<b>Office Action Summary</b>	Application No. 10/776,872	Applicant(s) HA ET AL.	
	Examiner Kathleen A. McNelis	Art Unit 1742

## DETAILED ACTION

Claims 13-17 are rejected under 35 U.S.C. 103(a) as being unpatentable over Magnet et al. (U.S. Pat. No. 6,062,043) in view of Rathbone (5,268,016).

FIG. 6

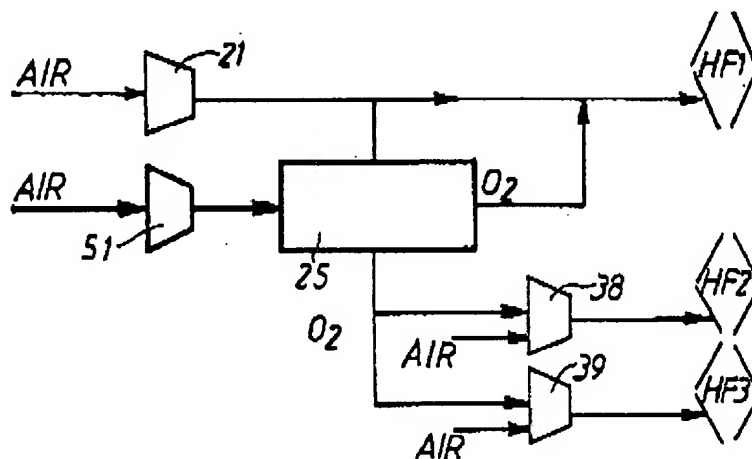
The embodiment of Magnet et al. shown on Fig. 6 meets the limitations of instant claim 13 as follows:

Magnet et al. discloses a method for feeding a gas-consuming unit (Magnet et al. claim 1) where the gas consuming unit is a blast furnace (Magnet et al. claim 11) where the feed flow is compressed in a compression unit (21) and a first part (28) is sent to the gas-consuming unit (i.e. blast furnace) and a second part is sent to a separation apparatus (25) which separates the mixture to produce two gas flows and the one at higher pressure is sent to the gas consuming unit (Magnet et al. claim 1). Further, Magnet et al. discloses that the separation unit (25) is also fed with air delivered by an air compressor (51) (Magnet et al. claim 6) as shown on Fig. 6 for HF1:

Magnet et al. does not disclose removing a second gas from the air separation unit and heating the second gas and expanding the second gas to recover energy.

With respect to claim 17, Magnet et al. discloses compressor (51) where additional air is compressed, passed through the air separator and mixed with the first portion as discussed above regarding claim 13.
